RE: Materials License 21-11315-02  
Request to amend license for synthesis/manufacture of radioactive compounds utilizing radiochemicals produced by the MPI Research cyclotron and transferred from the MPI Research production license, as described in the amendment application dated February 17, 2014 and subsequent communications

**Responses for questions posed during telephone conversation dated 09/05/2014  
to complete amendment request**

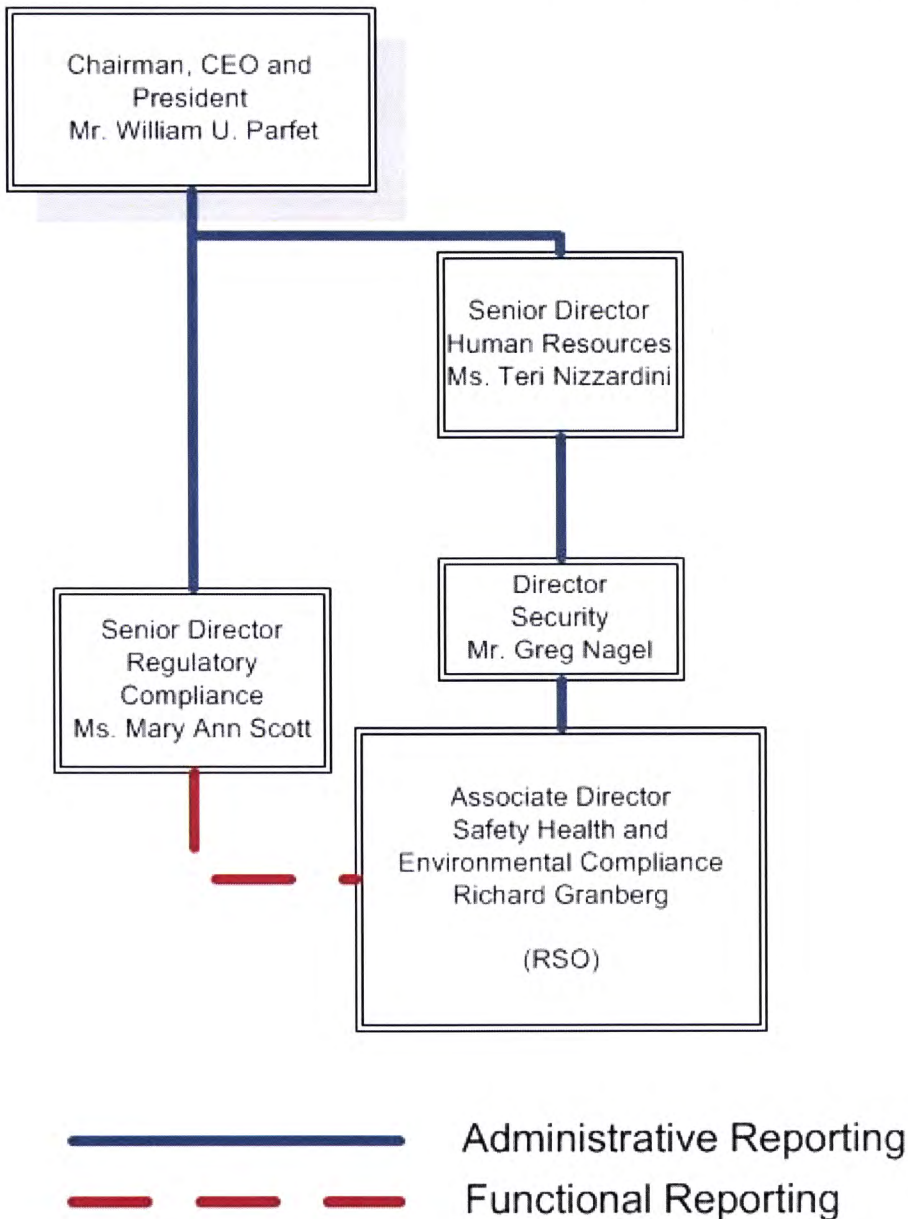
Question Number	Question Topic	Page
1	The license was renewed on June 24, 2014, following your submission of additional information regarding program management and staffing. Please provide any updates to your management organizational chart and/or your Radiation Safety Office staff that has changed management and staff availability to perform activities related to the use of accelerator produced radionuclides.	1 - 2
2	Please provide clearer diagrams of the T-Building exhaust ventilation system, including air exhaust flow direction arrows and clear connections from the first floor system to the penthouse ductwork and equipment. Please also confirm that any loss of air handlers for the T-Building would require immediate shutdown of cyclotron-related radiochemistry operations.	3 - 4
3	Regarding the February 17, 2014, amendment request letter, please:

Question 1:

The management structure (and RSO functional reporting structure) has changed since the broad scope license renewal application and the request for additional information on 06/06/2014. The current management structure is as follows:

The open health physicist position previously mentioned has not yet been filled, but interviews for the position continue and a current preferred candidate has been identified. If a more qualified candidate is not identified from upcoming interviews in approximately the next two weeks, an offer will be made to the current preferred candidate. MPI Research still expects at this point to have an applicant confirmed for the position by approximately end of third quarter. In any case, as committed to previously, Dr. Berridge will remain available to assist the RSO as required until the position is filled.

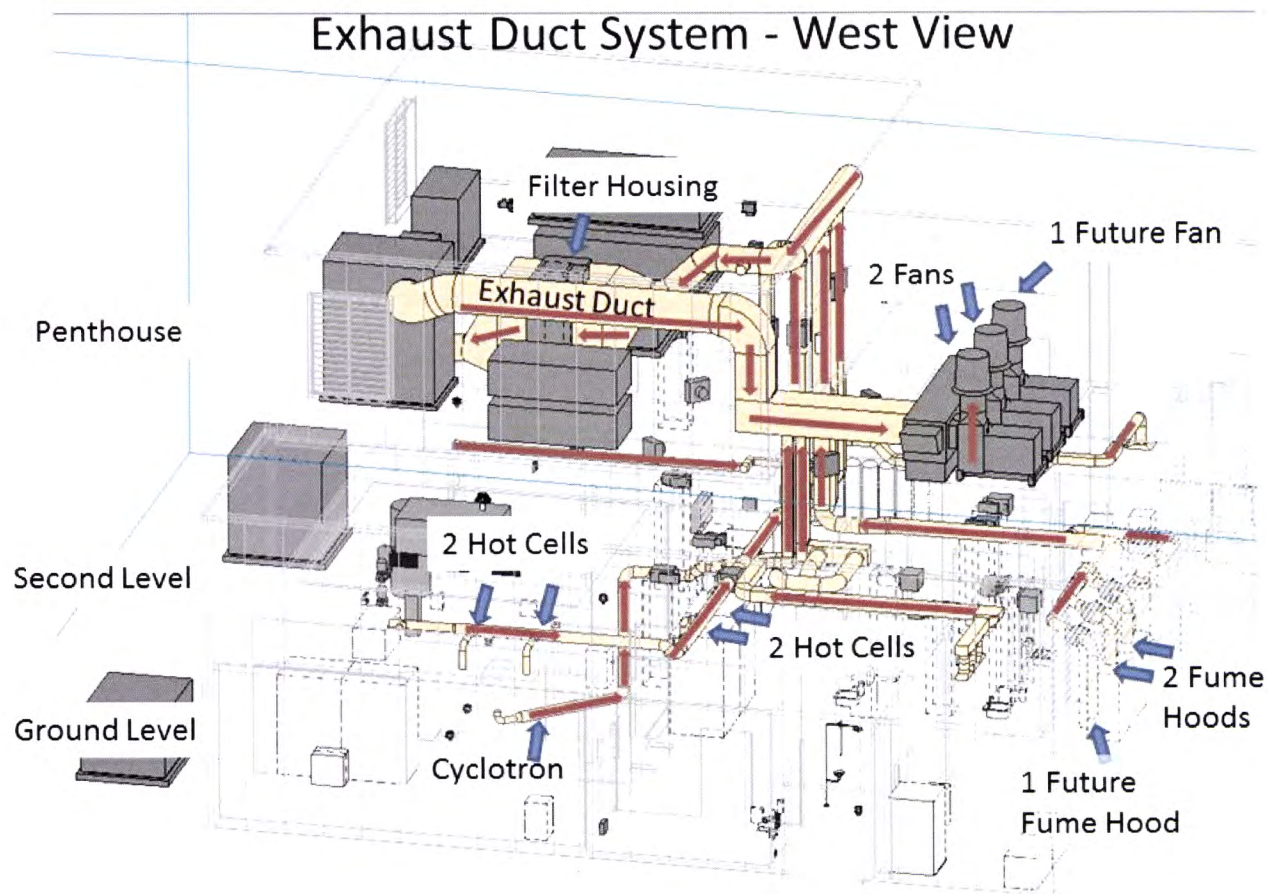
Question 2:

MPI Research confirms that any loss of air handlers for the T-Building will require immediate shutdown of cyclotron-related radiochemistry operations.

Requested diagrams of the T Building exhaust ventilation system are shown below:

This view of the T Building exhaust system shows the locations of the exhaust points for the four hot cells, two fume hoods, and the cyclotron (which exhausts from under the cyclotron). Air flow direction is shown with red arrows. Vertical ductwork is shown rising through second floor to penthouse. Penthouse exhaust is shown passing through carbon filter housing and out to exhaust fans. Note that capacity for an additional fume hood and an additional exhaust fan has been provided.

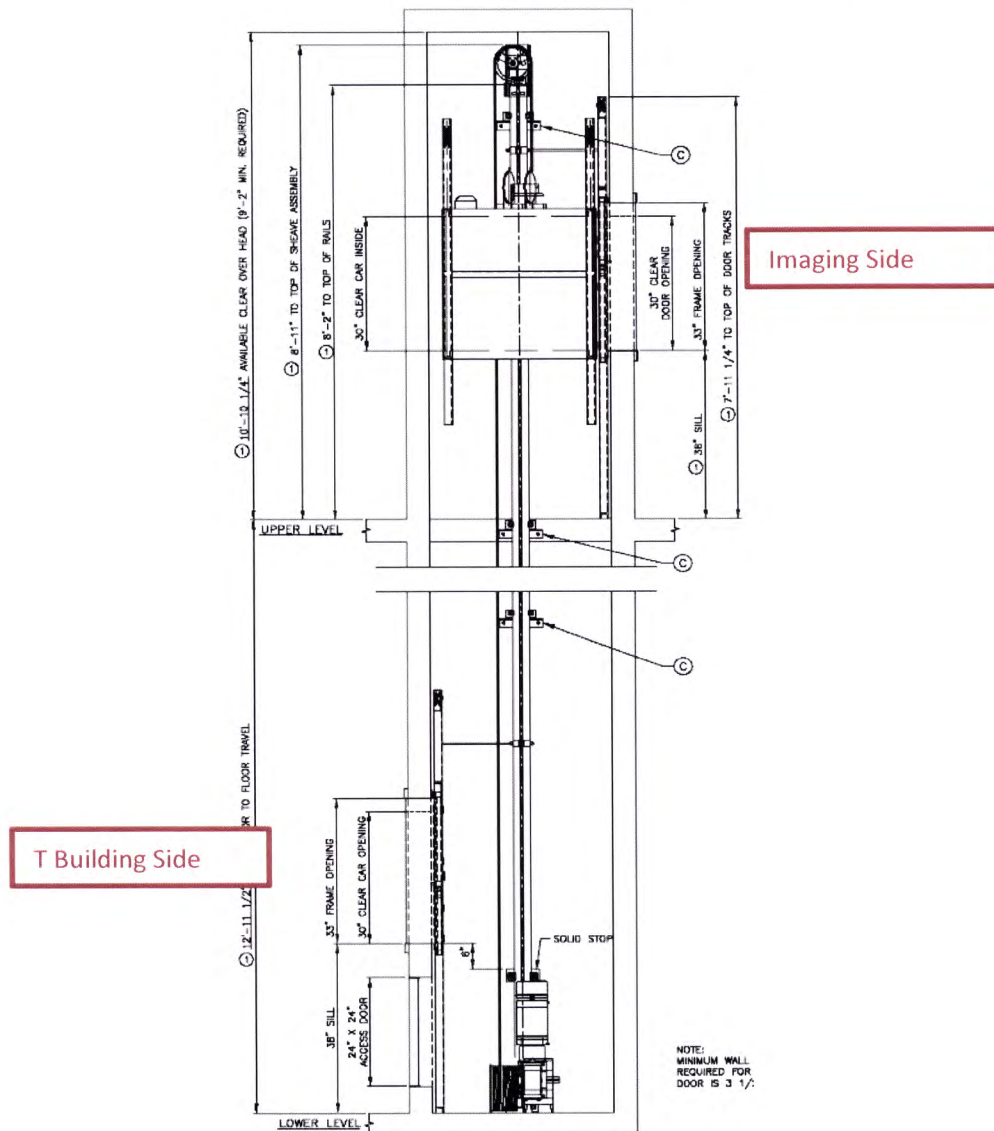
3.c	Describe the dumbwaiter system including whether it is dedicated to specific licensed use(s) and how shielding, security, control, and materials inventory updates are accomplished.	10 - 12

Question 3c:

A cross-sectional diagram of the dumbwaiter system is shown below:

The dumbwaiter is dedicated to movement of research materials from the first floor of the T Building to the Imaging area in the adjacent H Building (second floor), and

possibly return of materials to the T Building. The materials moved will be primarily radioactive materials to be used in MPI Research studies, but may also include non-radioactive materials also required to be transferred as part of the research activities. All materials will be associated with licensed activities under the MPI Research broad scope license. The only groups allowed access to and use of the dumbwaiter are the cyclotron facility staff and the Imaging staff. No other groups will be allowed access to or use of the dumbwaiter.

The dumbwaiter has no built-in shielding, although the wall in which the dumbwaiter is installed is filled concrete block. Adequate shielding is provided by the shielded container in which the transferred material is transported. Although not anticipated to be necessary, the dumbwaiter has the capacity to support additional shielding (in the form of lead bricks) to further shield the lead transfer container. All sides of the dumbwaiter except the back (North) side on the first floor abut restricted areas. The room to the north of the dumbwaiter is an infrequently occupied research room, Radiation levels in this room (controlled area) from movement of materials in the dumbwaiter are expected to be very low, and will be verified using posted area monitors. This room could also be controlled as a restricted area if necessary.

Dumbwaiter security is accomplished by the MPI Research keycard access control system that limits access to the first floor of the T Building, and then further limits access to the restricted area of the first floor T Building (where the lower end of the dumbwaiter is located) only to authorized personnel. The upper end of the dumbwaiter is located in the Imaging area, where access is similarly controlled using the keycard access control system only to authorized personnel. All access logs on all doors are recorded and time stamped for investigation if required.

Transfer of radioactive material by dumbwaiter is tightly controlled by close coordination between the T Building staff and Imaging staff to ensure that materials are transferred only when the receiving party is expecting them and is ready for them. T Building and Imaging will be in voice communication when the material is placed in the dumbwaiter, and the Imaging end of the dumbwaiter will be continuously observed until the material is retrieved. Communication will be maintained until the material is retrieved in Imaging. The reverse process will be observed for any transfers from Imaging to T Building. The RSO will be contacted immediately if the dumbwaiter fails with radioactive material onboard. Hand-carried materials are continuously attended from point of origin to point of turnover.
